CERTIFICATE OF APPROPRIATENESS

Property: 1702 North Boulevard, Lot 12, Block 3, West Edgemont Subdivision. The property includes a historic 2,136 square foot, single-family residence and a detached garage and service quarters situated on a 10,500 square foot (70' x 150') corner lot.

Proposal: Alteration – Previously Approved by HAHC June 2021, HP2021_0064. All elements or alterations remain the same as previously approved COA, except for the front elevation addition, enclosing of 1st floor rear breakfast roof, and Juliette balcony awnings from standing seam metal to canvas on detached guest quarters – see renderings

SOUTH ELEVATION – FRONT FACING NORTH BOULEVARD

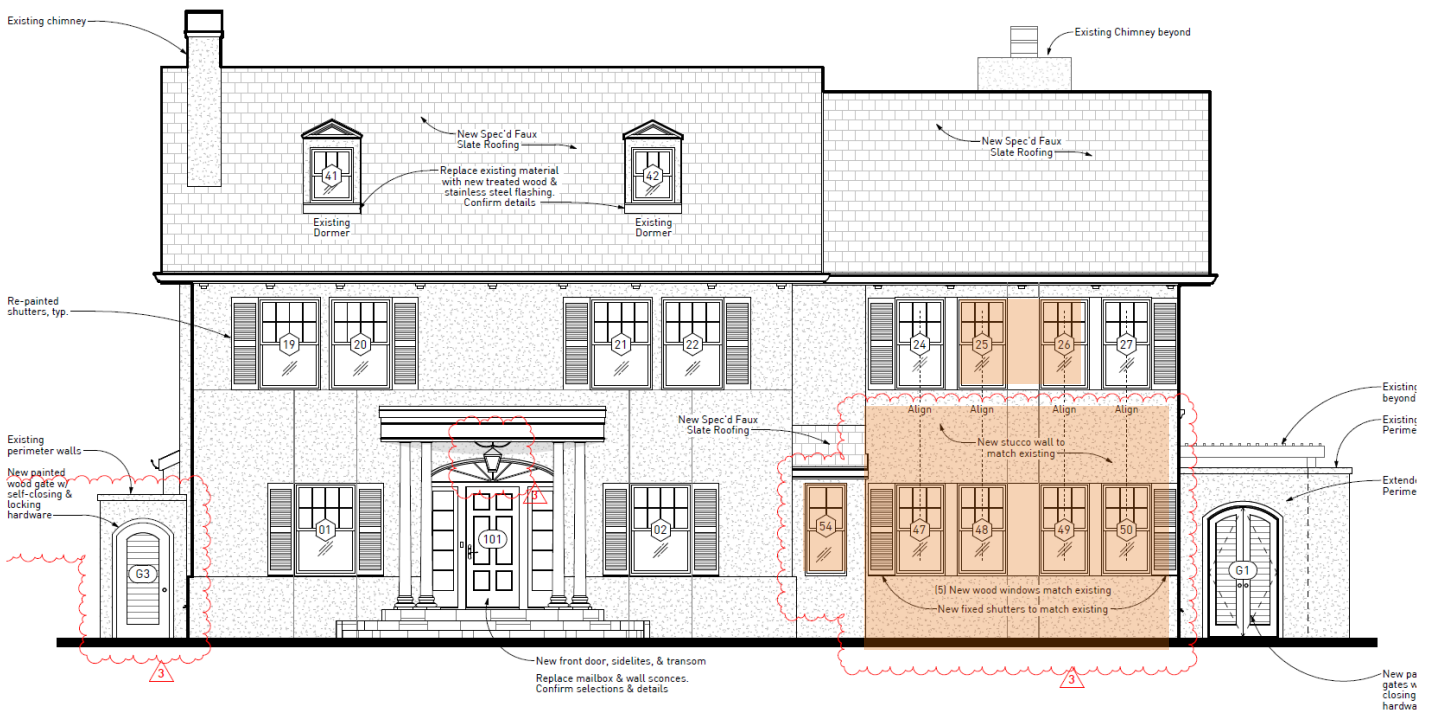
- Remove half cylinder, non-original 1980s addition at front elevation and regularize the non-original addition. Square footage is reduced by 8 sqft.
- Windows will be inset and recessed wood, in a narrower dimension to differentiate from the historic.

(3) The proposed activity must recognize the building, structure, object or site as a product of its own time and avoid alterations that seek to create an earlier or later appearance; Proposed window dimensions are smaller than historic, differentiating addition from historic portion.
